Amendment C369 to the Greater Geelong Planning Scheme: Drysdale Bypass

STATEMENT TO PLANNING PANELS VICTORIA BY HENRY TURNBULL, TRAFFIC ENGINEER

Traffic Engineering Assessment

Figure 16: Submission 19 Proposal

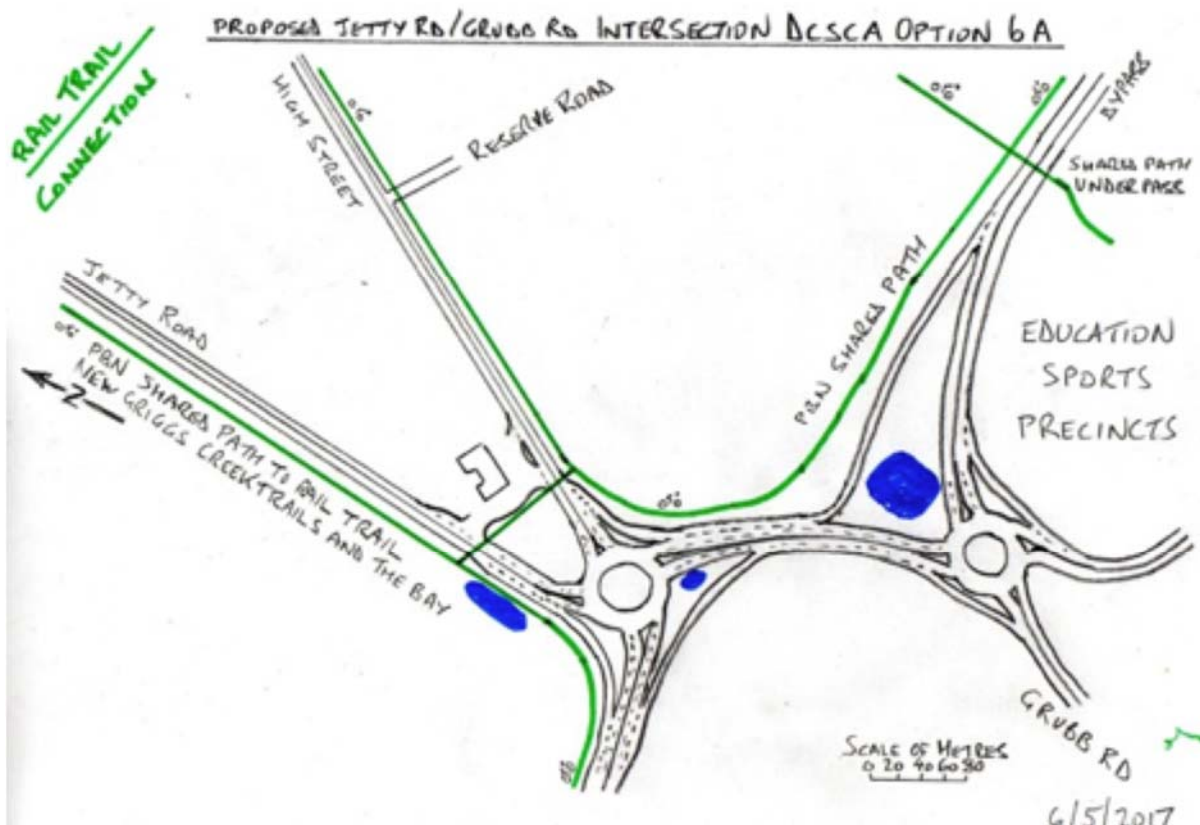
Submission 19 specifically requests design changes as shown in Figure 10 below.

Supplementary traffic modelling undertaken by GHD of the above proposal put forward by submitters demonstrates that from a purely traffic capacity perspective, the arrangement shown in Figure 10 would operate satisfactorily with the anticipated traffic volumes.

Figure 17: Submission 49 Proposal

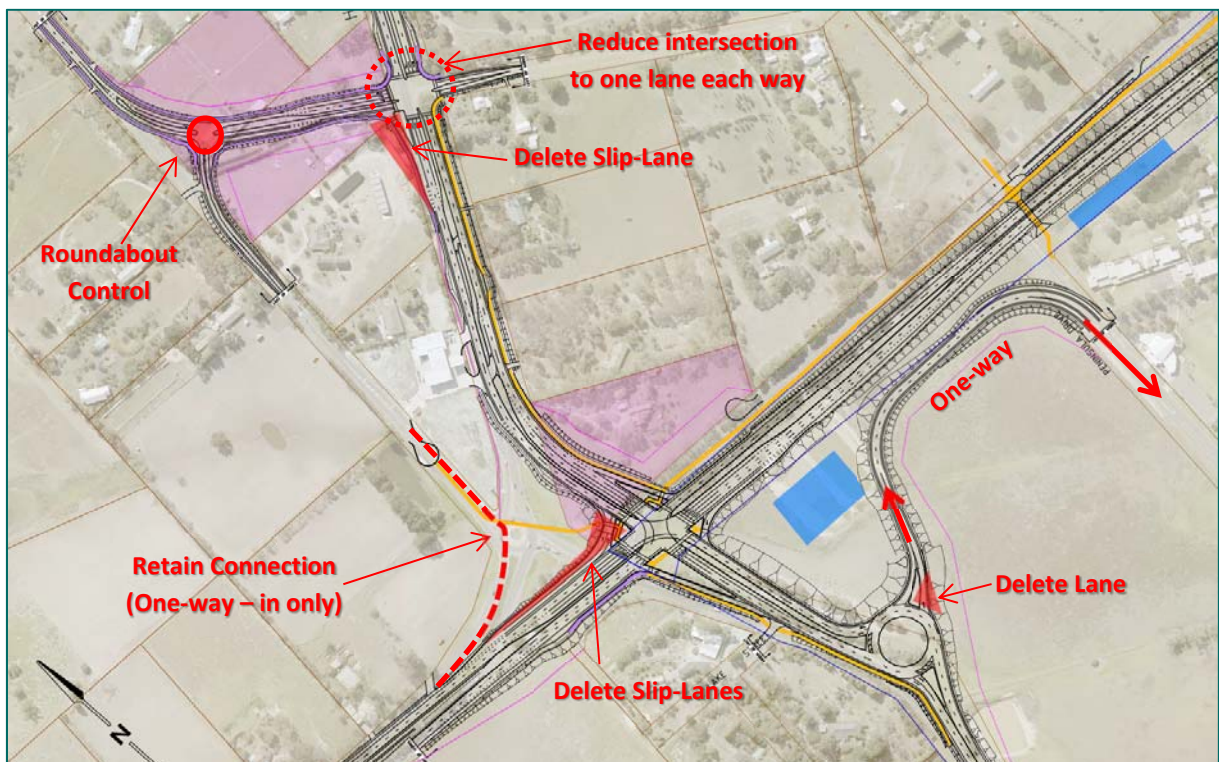
- Left-turn slip lane from Portarlington Road eastbound onto Jetty Road.
- Removal of dedicated left hand turn lane from Portarlington Road (eastbound) to High Street (northbound).
- Removal of dedicated left hand turn lane from High Street (northbound) to Reserve Road extension (westbound).
- Roundabout-controlled intersection at Jetty Road/Reserve Road extension.
- Reduction of High Street/Reserve Road intersection to single lanes.
- One-way (southbound) traffic flow in Peninsula Drive.
- Extension of Peninsula Drive to Belchers Road.
- Roundabout-controlled intersection at Belchers Road/Grubb Road.

Figure 11 below shows these proposals.

The requests shown in Figure 11 are intended to be a “package” of changes, and not considered in isolation. Notably, the justification for the removal of left-turn slip lanes from Portarlington Road to High Street and from High Street to Jetty Road are noted as being a result of the proposed provision of both the left-turn slip-lane directly into Jetty Road, as well as an anticipated decreased number of vehicles using Jetty Road at such time that a new north-south connector road is constructed approximately 1km/ west of the High Street/ Portarlington Road intersection.
